**IMPACT OF BREAKWATERS AND TRANSPORT
CARRIER ON THE EROSION/ACCRETION
FOR THE VADHAVAN PORT, MAHARASHTRA**

**JAWAHARLAL NEHRU PORT AUTHORITY
GOVERNMENT OF INDIA**

October 2023

Figure 4.1.3: Wave transformation from West Direction

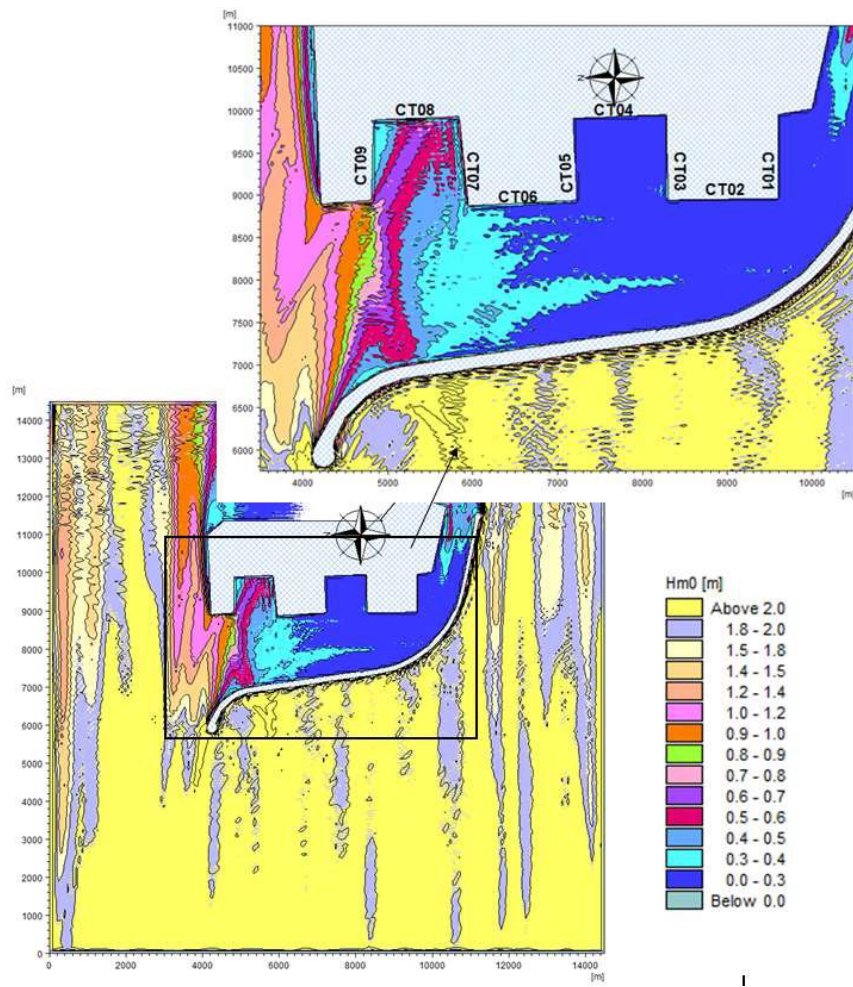
The nearshore wave transformation indicates a maximum significant wave height of 1 m with a peak wave period of 10 seconds when the wave direction is NW with the wave height slightly higher than the limiting wave height of 0.7 m in the WNW direction wave at CT08. All the other observed wave data are within the limits (Table 1). The wave transformation in the west direction is represented in Figure 4.1.3.

The study suggests a tranquil condition inside the port basin and also since the breakwater is constructed offshore, blockage of sediments along the coast cannot be anticipated. However, there could be a possibility of the formation of a salient behind and south of the proposed port, which needs to be monitored.

Figure 4.2.1: Modified revised Master Plan Layout

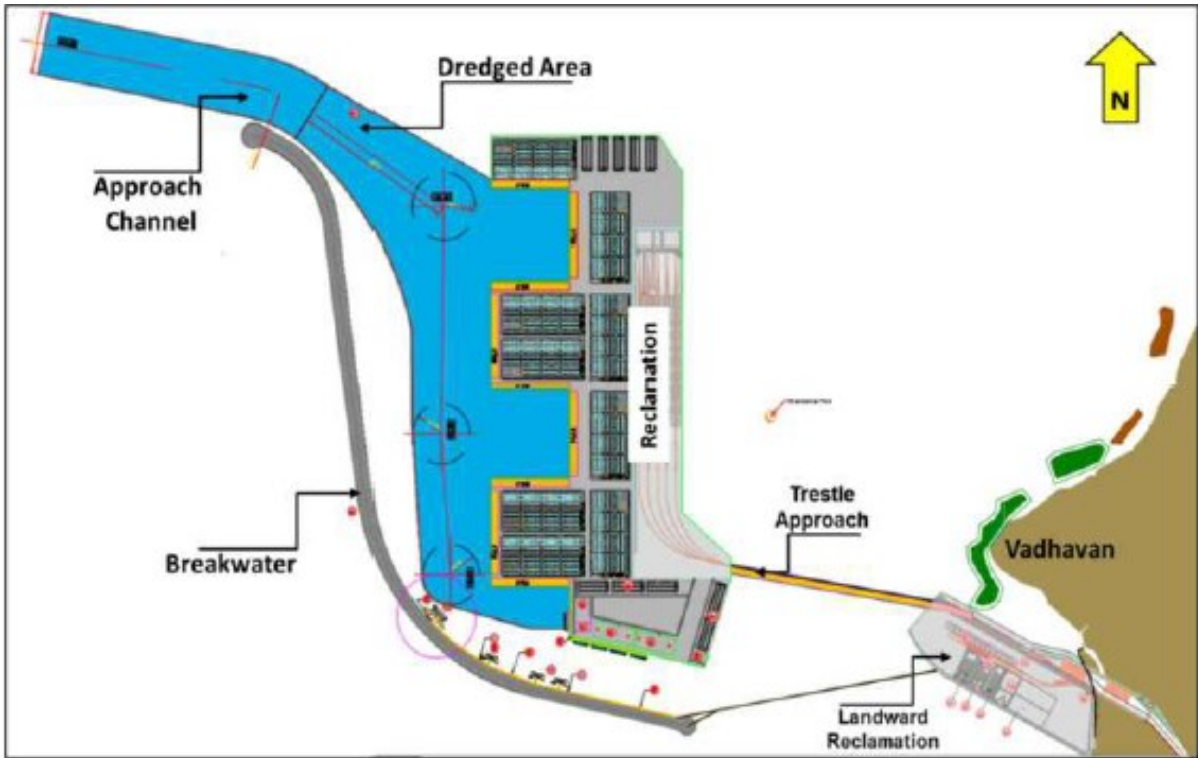
A revised master plan inclusive with the breakwater of length 10.3 km, offshore reclamation, and dredging footprint viz. proposed reclamation area (offshore 1262 Ha. & Shore connected 222 Ha) with 1210 Ha of the dredged area was finalized as shown in figure 4.2.1. The location of various berths as in the finalized Master Plan is given in Figure 4.2.2. From the hydrodynamic and siltation studies, it was confirmed that the tidal flow conditions are suitable at all container berths and manoeuvring areas and also consider the width between the breakwater and multipurpose berth to 670m.

The hydrodynamic and siltation studies of this Master Plan were carried out and it was observed that the maximum current strengths at the container are within 0.15 m/s. The flow approaches at an angle varying between 4° and 7° along oil berths and LPG terminals. With these flow conditions, it was reported that the currents would bypass the sediments to the North of the proposed port. The total quantum of likely siltation in the dredged areas will be about 8.45 million cum per annum as per the siltation studies. With the advised maintenance dredging of 6.45 million cum for phase I, a volume of 0.15 Mm³ from this maintenance dredging can be used for beach nourishment to the immediate North of the port.

Figure 4.3.1: Shoreline Change Analysis by NCSCM (1975-2022)

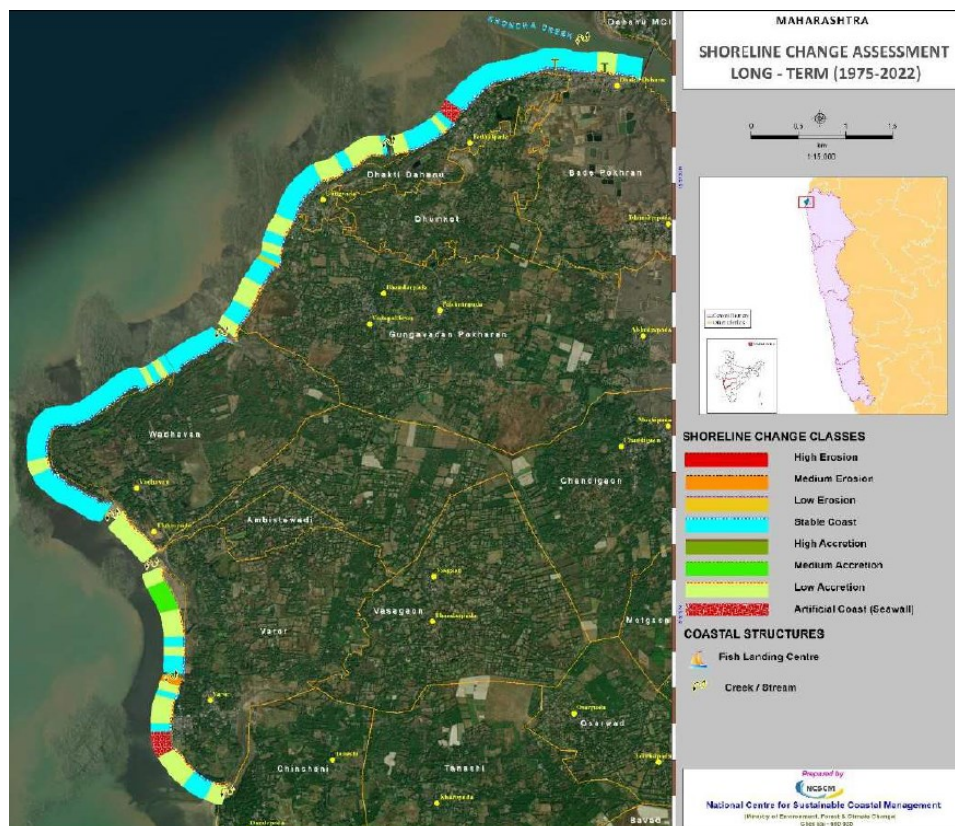
The study on shoreline change assessment was carried out and submitted to JNPA in April 2022. The analysis covered long-term (1975-2022) and short-term (2000-2022) shoreline changes using historic satellite images and aerial photographs from 2012 (Table 2). In the long term, 61% of the coast was stable, while in the short term, 50% of the coast was considered stable, with some stable areas transitioning to low erosion. Additionally, areas of low accretion in the long term were gradually trending towards low erosion. Figure 4.3.1 illustrates the presented analysis results.

It is seen that from Khonda Creek to the North of the proposed port area, the shoreline trend indicates the shoreline transferring from broadly stable to low accretion coast. At the port location and reclamation area, the shore has shifted from broadly Stable to low accretion coast. South of the location till the Varor region, a significant proportion of the regions range from low erosion to medium erosion.

Figure 4.4.3: Model Output for Shoreline Evolution

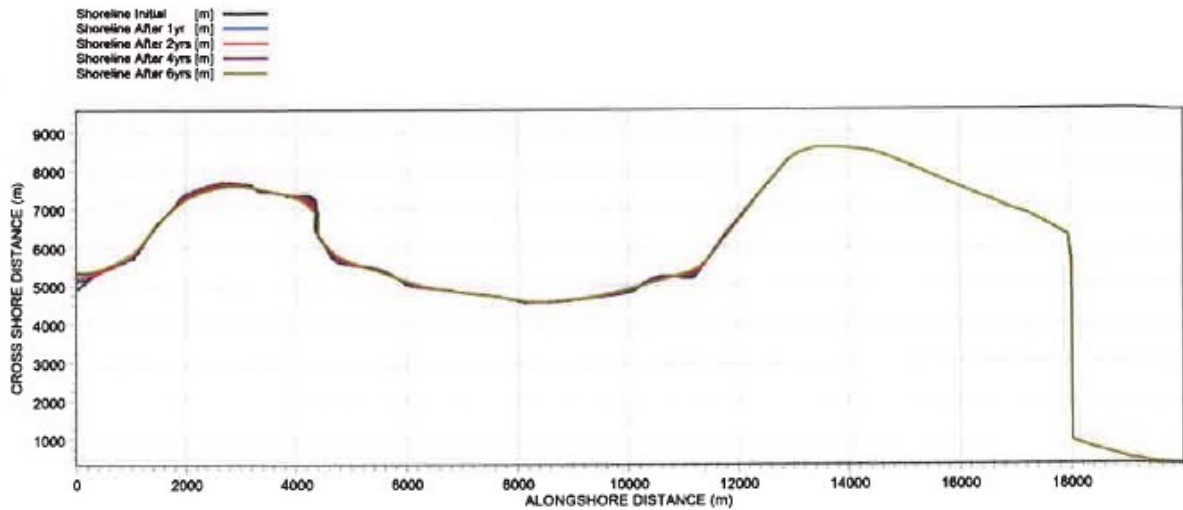
The LITLINE module of the LITPACK software is used for assessing the impact of ports on the coastline. The shoreline length for the study extends for 20 km and the nearshore annual wave climate at -24m water depth was considered for the shoreline evolution of 1, 2, 4, and 6 years with the proposed breakwater and reclamation. The model output is shown in Figure 4.4.5.

The study concludes negligible shoreline advancement with the proposed breakwater at Vadhavan and the shoreline evolution after 1, 2, 4, and 6 years was drawn. This study also concludes that there will be negligible impact on the adjacent shoreline of the proposed port area.
